Neasa Hourigan
Leinster House
Kildare Street
Dublin 2

Dublin City Planning Department
Civic Offices
Wood Quay
Dublin 8

26th September 2022

We wish to comment on the above planning application on behalf of Neasa Hourigan TD and Cllr. Darcy Lonergan.

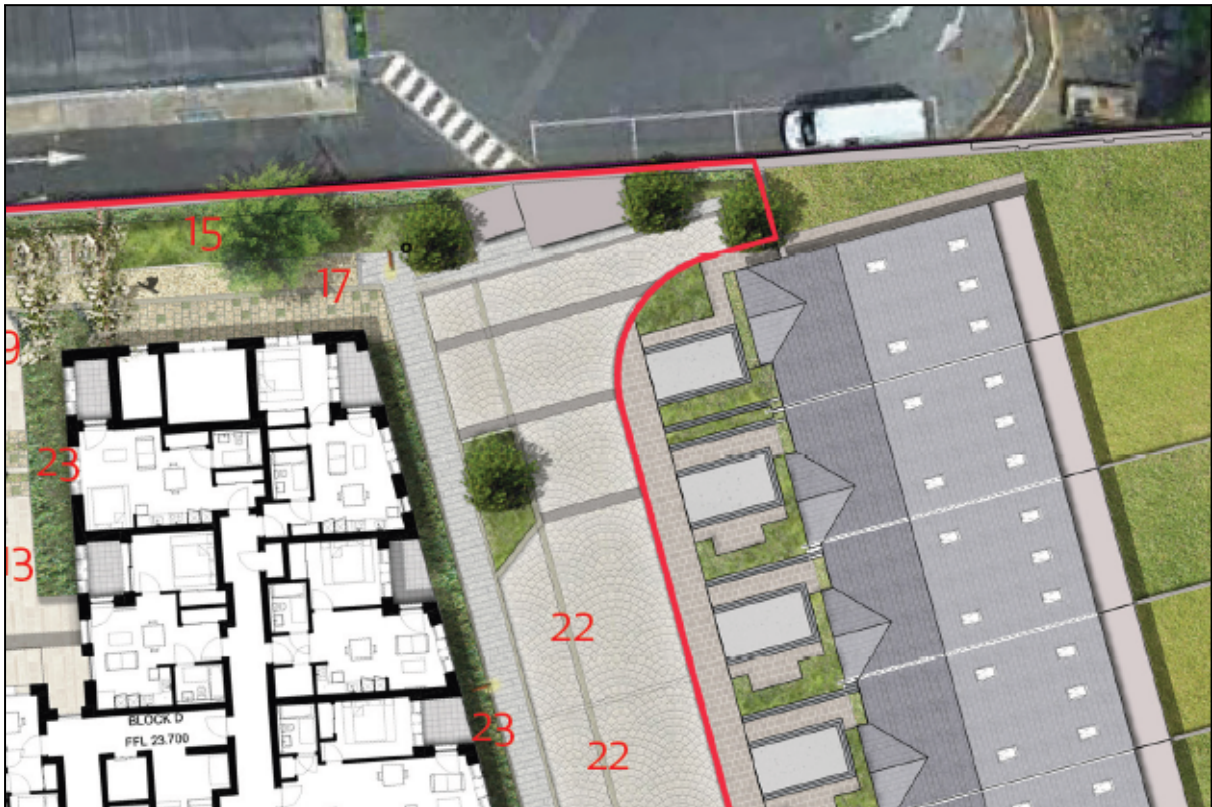
dealt with external to the scheme we feel that pedestrian/cycle permeability of the overall scheme is important. A condition of the grant should be that pedestrian/cycle permeability be achievable when the remainder of the site is developed. It currently looks like any permeability at the North East corner is obstructed by bin storage.
